City of Portland, Maine - Building or Use Permit Application

Location of Construction: 15 Vaughan St	Owner Name: Meacham Sarah S	Owner Address: 15 Vaughan St	Phone: 207-780-6640
Business Name: n/a	Contractor Name: Rosewood Design & Const. Co.	Contractor Address: P.O. Box 8248 Portland	Phone:
Lessee/Buyer's Name n/a	Phone: n/a	Permit Type: Alterations - Dwellings	Zone: R-4

DATE: 10 September 2001 ADDRESS: 15 Vaughan Street CBL: 061-E-001

REASON FOR PERMIT: Interior/Exterior renovations (Single Family)

COPIES	DATE	NO.	DESCRIPTION
<u>1</u>			<u>PLAN WITH COMMENTS</u>

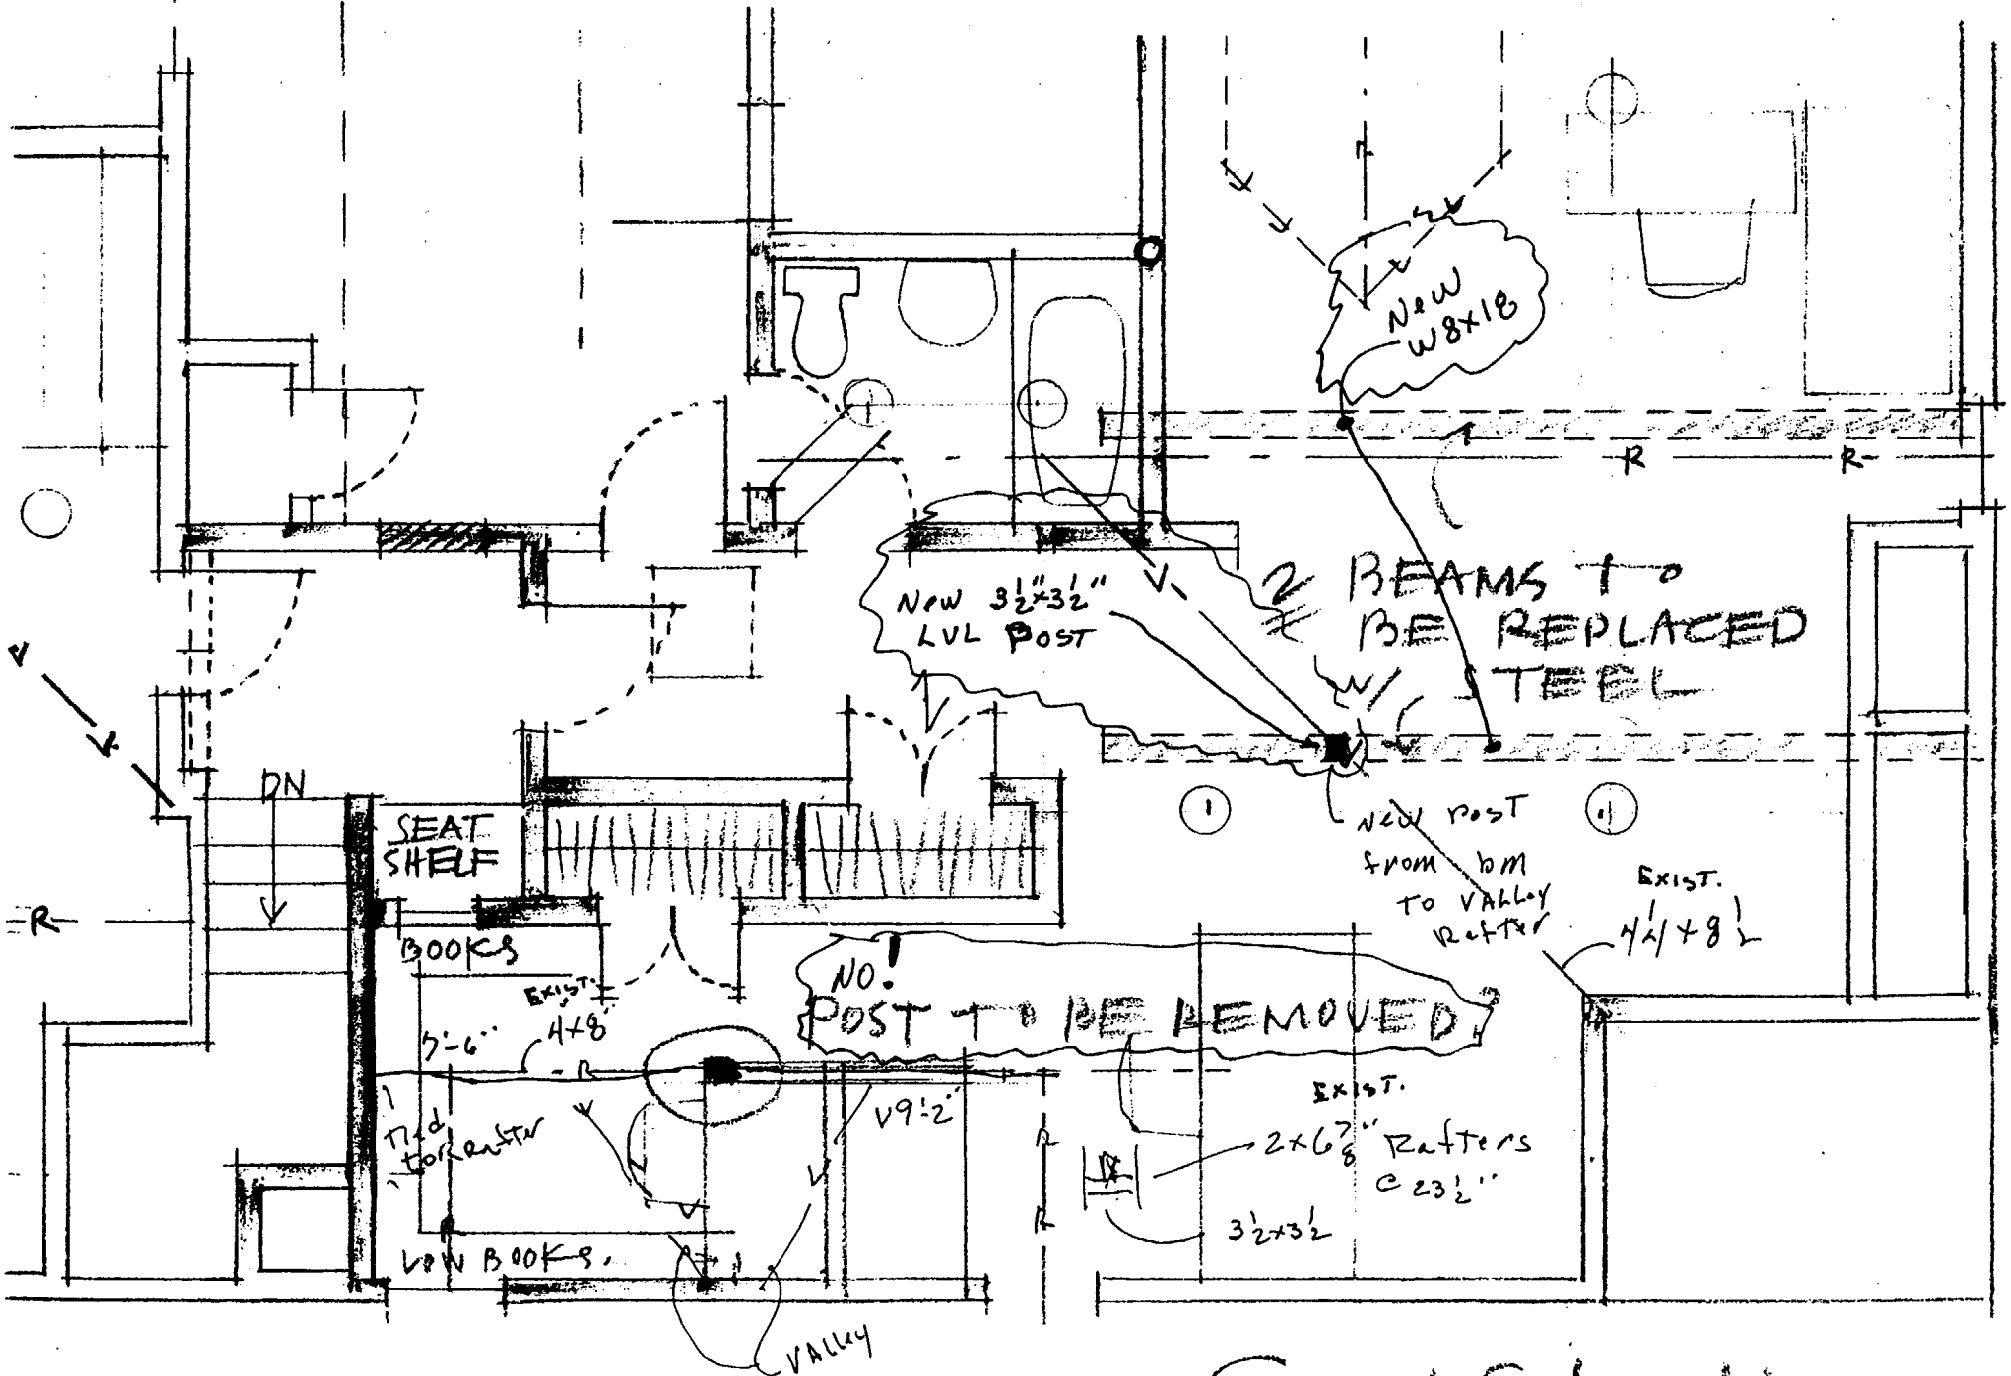
REMARKS _____
I think we should leave the post. If we take it out, we would
need larger beam and would ^{be} doing something with the rafters that
support the beam. This could change loading below also.
